Access Compliance Report

Public Rights-of-Way

Intersection ID: N/A	Main Street: BEREWICK COMMONS PKY	Cross Street: STONEWELLS DR	Location: S
ADA ID: FB6039984D0A	Ramp Type: PerpDiag	Initial Pass/Fail: Fail	Overall Compliance: No
		Severity Score: 12.5

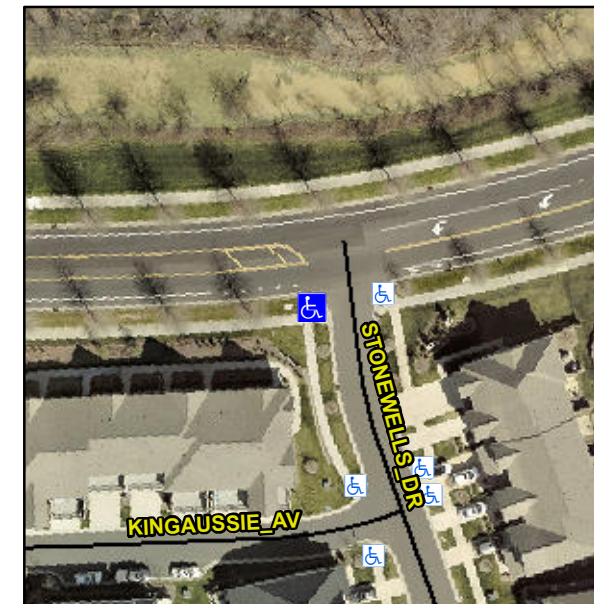
Not Found, R304.2.2

Compliance	Description	Data	Compliance	Description	Data
N/A	Ramp Length (in)	90.0	No	Ramp Slope (%)	9.2
Yes	Ramp Width (in)	60.0	Yes	Ramp XSlope (%)	1.9
N/A	Flare Type LT	N/A	N/A	Flare Type RT	N/A
N/A	Flare Slope LT (%)	N/A	N/A	Flare Slope RT (%)	N/A
N/A	Flare Traversable LT?	N/A	N/A	Flare Traversable RT?	N/A
N/A	Landing Length (in)	N/A	N/A	DWS Provided?	N/A
N/A	Landing Width (in)	N/A	N/A	DWS Contrast?	N/A
N/A	Landing Slope (%)	N/A	N/A	DWS Length (in)	N/A
N/A	Landing X Slope (%)	N/A	N/A	DWS Full Width?	N/A
N/A	Landing Curb? (Y/N)	N/A	N/A	DWS Offset (in)	N/A
N/A	Shared Landing?	N/A			
N/A	Gutter Ponding?	N/A	N/A	Gutter Slope (%)	N/A
N/A	Gutter Lip Ht (in)	N/A	N/A	Gutter X Slope (%)	N/A
N/A	Painted X Walk1?	No	N/A	Painted X Walk2?	No
	X Walk 1 Direction	To E		X Walk 2 Direction	To N
N/A	X Walk 1 Width (in)	N/A	N/A	X Walk 2 Width (in)	N/A
	X Walk 1 Slope (%)	0.2		X Walk 2 Slope (%)	2.0
	X Walk 1 X Slope (%)	0.1		X Walk 2 X Slope (%)	1.2

Remove & Replace Curb Ramp With Two New Directional Ramps or Equivalent.
